### **End of Sale Notification for Carbon Steel Miniature Linear Guide Products of MISUMI**

**Sheet No.1**

**Material Modification, from Carbon Steel to Stainless Steel, of Miniature Linear Guides**

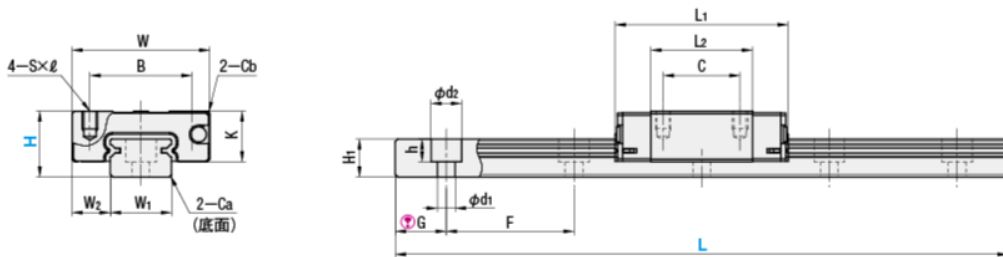
There is no modification in Dimension of Product.

Modification in Material, from Carbon Steel to Stainless Steel (Equivalent to SUS440C), is the only change.

Material will be modified from Carbon Steel to Stainless Steel. There is no modification in Specification, Allowable Load Capacity, Allowable Moment, Standard Accuracy, and the others.

In order to modify Part No. to Stainless Steel Product, please add a [S] to the top of Carbon Steel Products Part No. For Low temperature black chrome plating product, please add a [S] next to [R].

[Carbon Steel] S E B 10 - 55 ⇒ [Stainless Steel] S E B 10 - 55

[Carbon steel] R E B 10 - 55 ⇒ [Stainless Steel] R S E B 10 - 55
